## QUAD-5 Preset Echo Modification

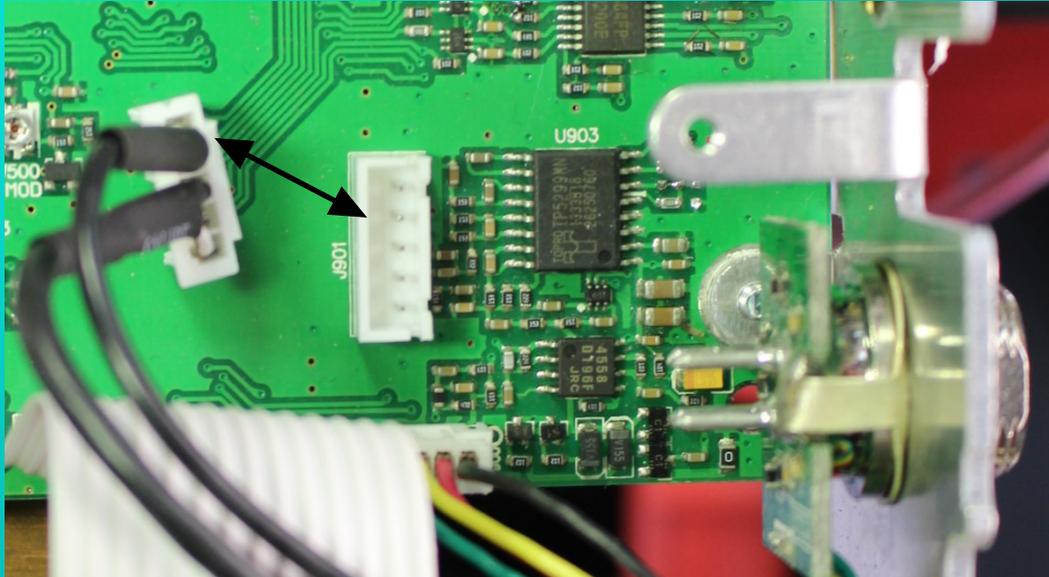
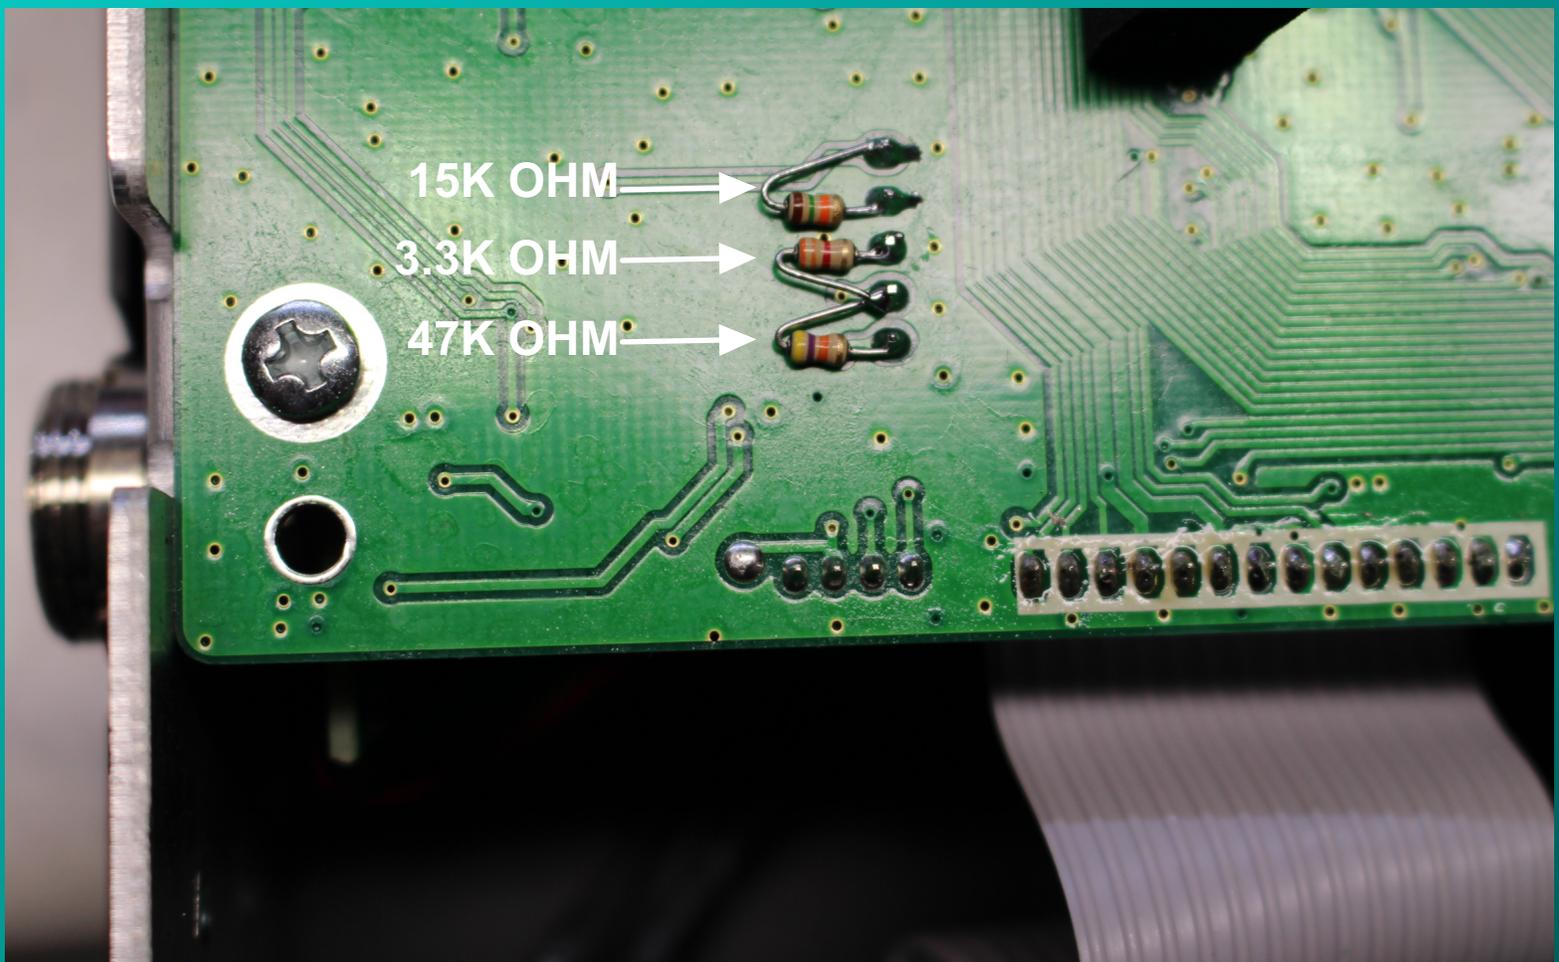
Unplug the connector from J901

Add the following resistors to the back of J901

The echo ON/OFF portion of the control still works, the only difference is the effect stays the same and will never go out of adjustment.
